Service Bulletin

Cargo Door Forward Slide, operating rod and handle.

SB-GA8-2005-23
Issue 5

Figure 3: Worn slider indicating where to measure.

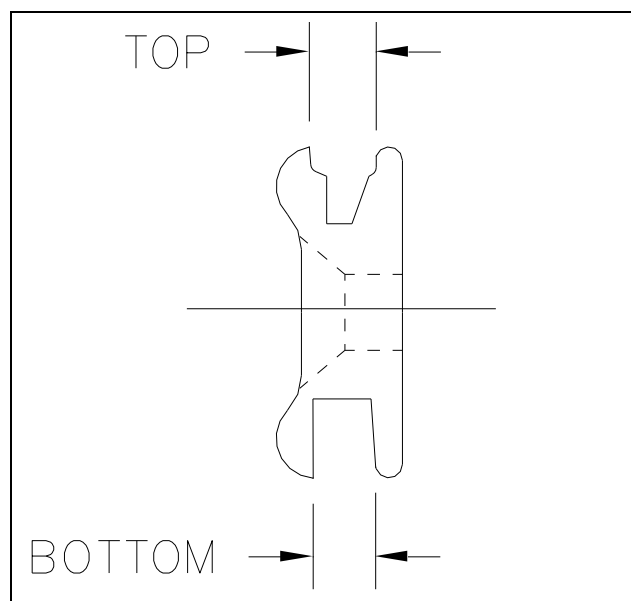
3. Figure 3 below shows how a worn part normally looks and where to measure the groove width. The TOP and BOTTOM profile differs on a worn part and as such both the top and bottom slide grooves are to be measured with a calliper.

4. Measure the groove width and if the groove is wider than 0.145" at any point along the slider or if the part is cracked or excessively worn a new slider, Item 1, must be fitted.
5. Irrespective of Item 1, Items 2 to 7 MUST be fitted as shown in Figure 4 and listed in below.

Figure 5: Checking with the Forward Slide Gauge (all four corners require checking)

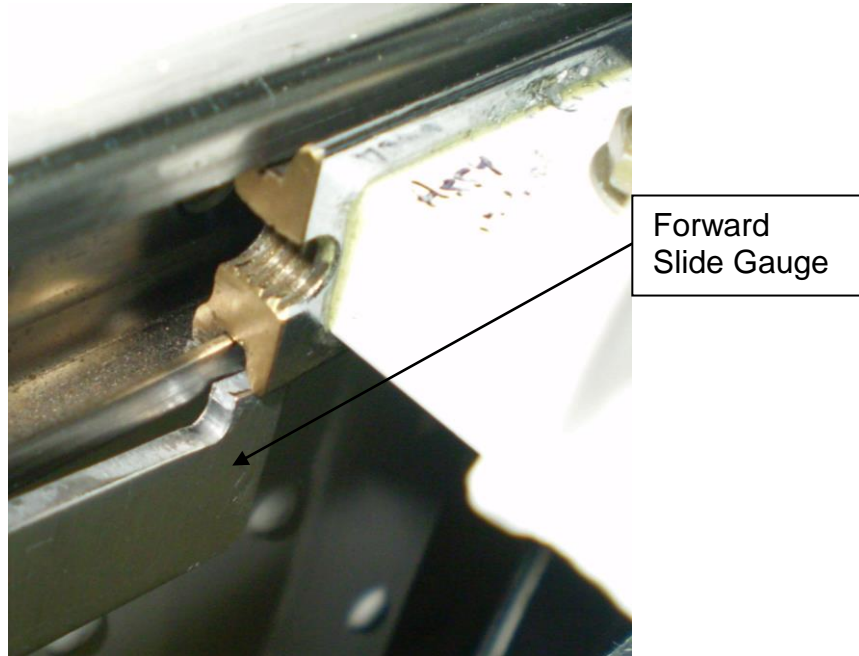
1. Open the door handle so that the door swings out to gain access to the slider (see ACTION 1, Para 1)
2. Try to insert the Forward Slide Gauge (Item 8, Table 2) between the slider and the track as shown in Figure 5 and Figure 6 below. Standard Feeler gauges made up to 0.098" (0.023"+0.024"+0.025"+0.026") may also be used.

3. If it is possible to fit the Forward Slide Gauge or feeler gauge between the track and slider (as shown in Figure 6 above) at any of the four corners carry out ACTION 1 Para 2 to 4.

Figure 8: Rear Door Handle Mechanism - Inspection Areas

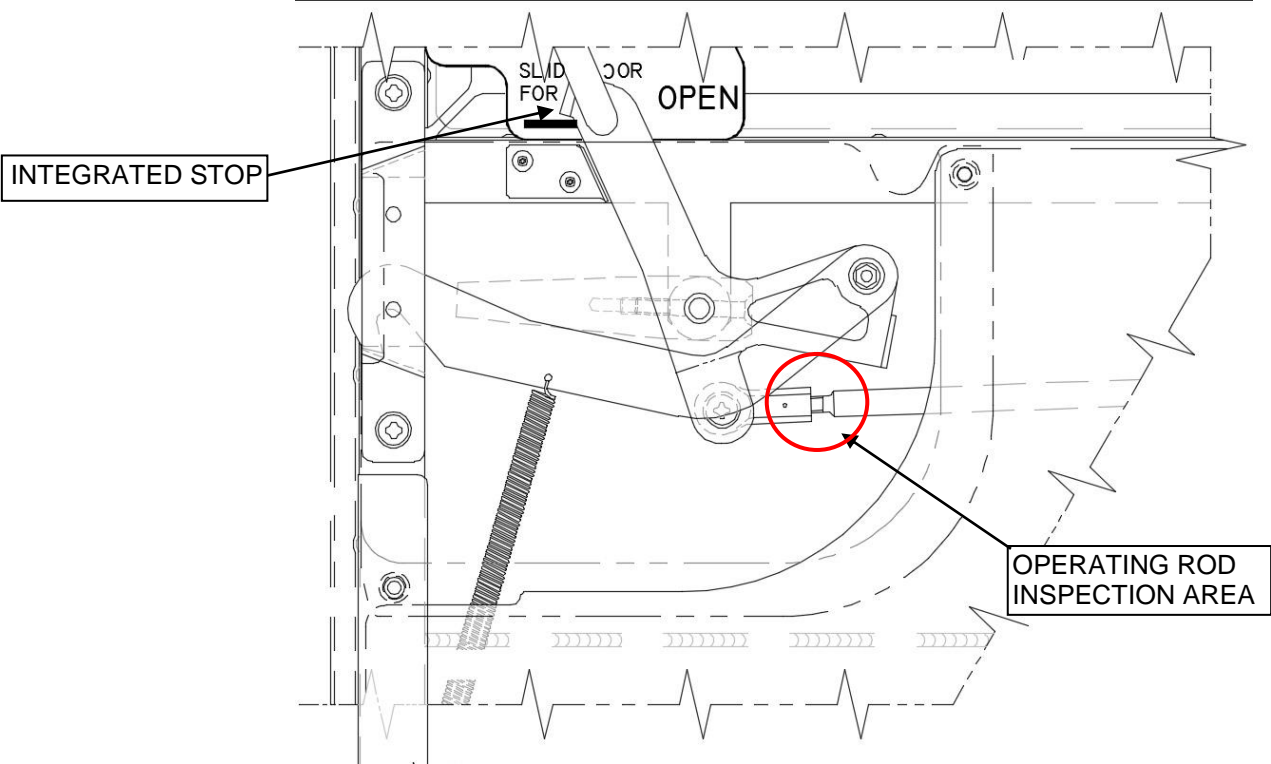
1. Remove Rear Mechanism Cover, refer to Figure 7.
2. Inspect threaded stud at the end of the operating rod, refer to Figure 8. If there is any indication of bending then either replace the operating rod with Item 9 from Table 3 or locally modified rod detailed in Part B2 using the following steps.
3. Disconnect the rod ends from the handle and pivot arm. Remove the forward rod end and pull out the operating rod.
4. Install the operating rod through frame bush prior to installing forward Rod End. Install rod ends and connect to the handle and pivot arm.

Figure 9: Rear Door Handle Pivot Post – Rework Area

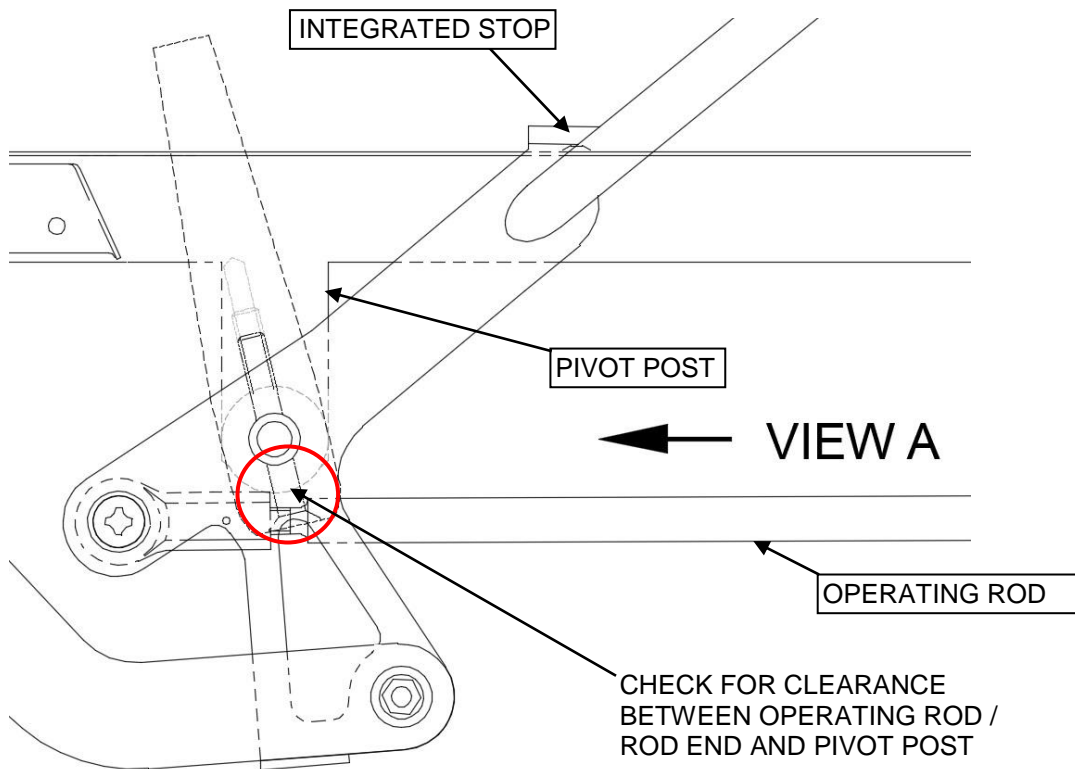
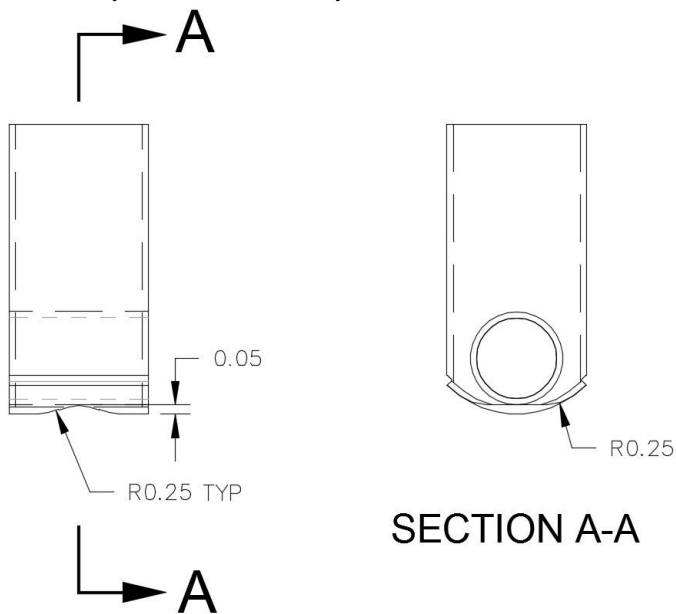
5. With the door handle held fully open / against the stop, check that the operating rod does not hard foul against the rear door handle pivot post, refer to Figure 9. If required rework the rear door handle pivot post.
6. Reinstall the Rear Mechanism Cover, refer to Figure 7.

1. Only Pivot post shown for clarity
2. Rework using blending guidelines of AC43.13-1B Chapter 6 Section 7 and 10
3. Ensure rod end and rod have a min clearance of 0.040in from pivot post
4. Restore surface protection IAW Service Manual

Figure 12: Rod Modification (P/N: SB-GA8-2005-23-02)

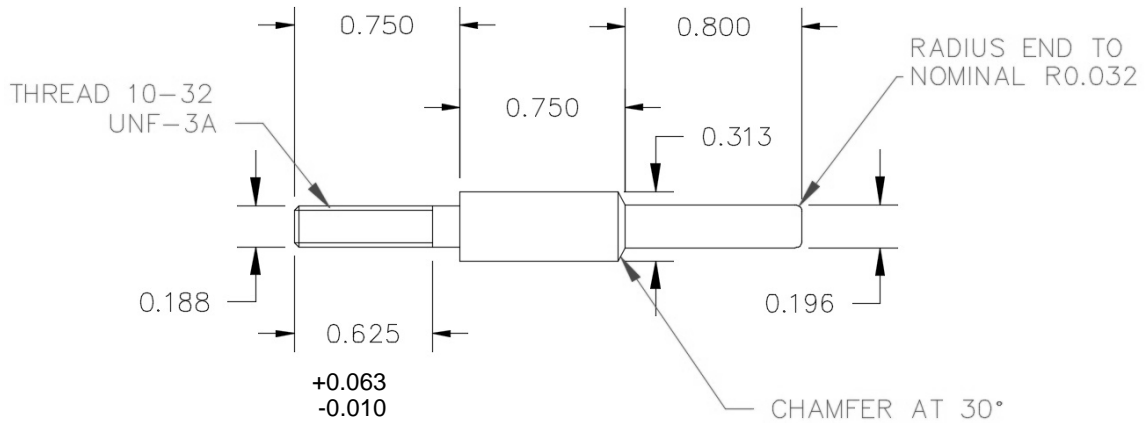
1. From 4130 Rod (MIL-S-67580.0500 manufacture 1 off Rod End Repair SB-GA8-2005-023-01, as shown in Figure 10.
2. Trim 0.75in from the end of the operating rod, chamfer at 30° and drill two Ø0.188in holes, refer to Figure 11.
3. Weld Rod End Repair SB-GA8-2005-023-01 to the trimmed rod, refer to Figure 12.

1. NOT TO SCALE
2. Weld in accordance with Chap 51-20-00 of the GA Service Manual. Grind / finish all welds flush. Filler wire / consumable AWS 5.28: ER80S-B2 or equivalent
3. Apply primer 2.0in past the repair area that conforms to MIL-PRF-23377K (or later approved revision) or FEDSPEC-TT-P-1757B (or later approved revision). Apply topcoat of paint that conforms to MILPRF-85285E (or later approved revision) and matches the surround colour.
4. Using indelible ink, permanently part mark the modified operating rod as SB-GA8-2005-23-02
